Index 700-102 Special Sign Details

STANDARD PLANS

700-102

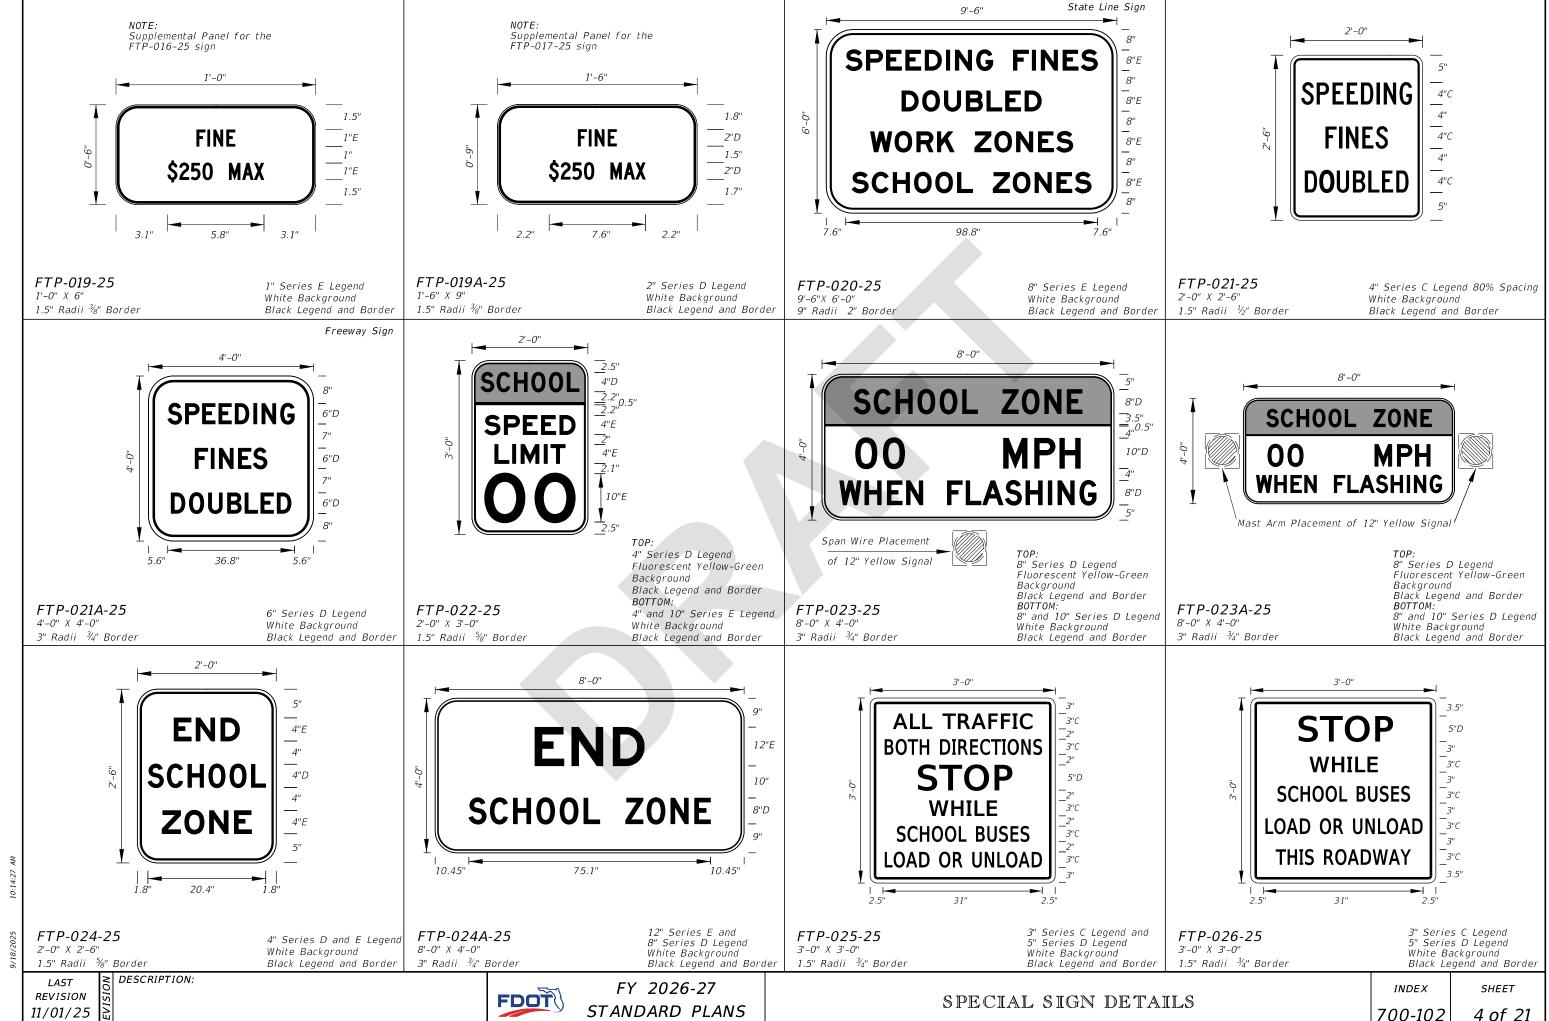
COMMENT: It's not clear the total number of yellow flashers to be installed in FTP-022-25 and FTP-

022A-25 signs.

RESPONSE: Thank you for your comment. These signs have been updated to remove the middle flashing beacons.

CHANGE MADE TO INDEX: Yes.
